Access Compliance Report

Public Rights-of-Way

(Curb Ramps)

Intersection ID: 24472	Main Street: CARMEL_RD	Cross Street: QUAIL_VIEW_RD	Location: NE
ADA ID: 02EB5D03AAC9	Ramp Type: PerpDiag	Initial Pass/Fail: Fail	Overall Compliance: No
Severity Score: 22.5			
Codes/Mitigation Info/Possible Solution		Field Measurements/Component Compliance

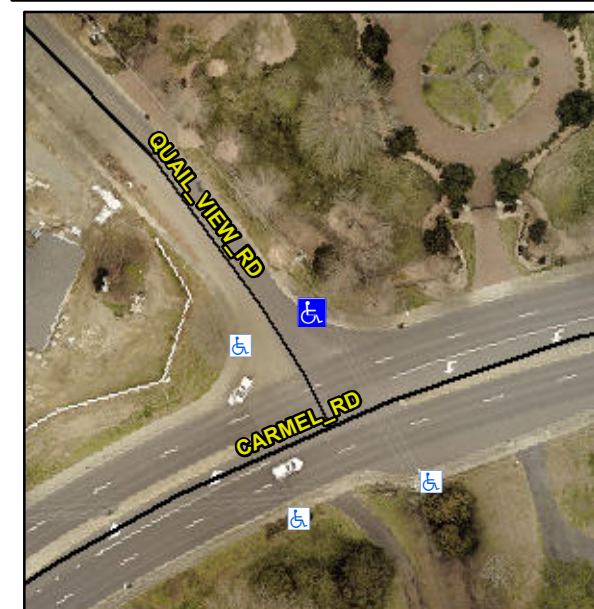
Not Found, R304.5.1, R304.2.2, R304.5.3

Compliance	Description	Data	Compliance	Description	Data
N/A	Ramp Length (in)	59.0	No	Ramp Slope (%)	10.2
No	Ramp Width (in)	47.0	No	Ramp XSlope (%)	2.5
N/A	Flare Type LT	N/A	N/A	Flare Type RT	N/A
N/A	Flare Slope LT (%)	N/A	N/A	Flare Slope RT (%)	N/A
N/A	Flare Traversable LT?	N/A	N/A	Flare Traversable RT?	N/A
N/A	Landing Length (in)	N/A	N/A	DWS Provided?	N/A
N/A	Landing Width (in)	N/A	N/A	DWS Contrast?	N/A
N/A	Landing Slope (%)	N/A	N/A	DWS Length (in)	N/A
N/A	Landing X Slope (%)	N/A	N/A	DWS Full Width?	N/A
N/A	Landing Curb? (Y/N)	N/A	N/A	DWS Offset (in)	N/A
N/A	Shared Landing?	N/A			
N/A	Gutter Ponding?	N/A	N/A	Gutter Slope (%)	N/A
N/A	Gutter Lip Ht (in)	N/A	N/A	Gutter X Slope (%)	N/A
N/A	Painted X Walk1?	No	N/A	Painted X Walk2?	No
	X Walk 1 Direction	To SW		X Walk 2 Direction	To SE
N/A	X Walk 1 Width (in)	N/A	N/A	X Walk 2 Width (in)	N/A
	X Walk 1 Slope (%)	2.1		X Walk 2 Slope (%)	1.9
	X Walk 1 X Slope (%)	1.5		X Walk 2 X Slope (%)	1.0

Remove & Replace Curb Ramp With Two New Directional Ramps or Equivalent.
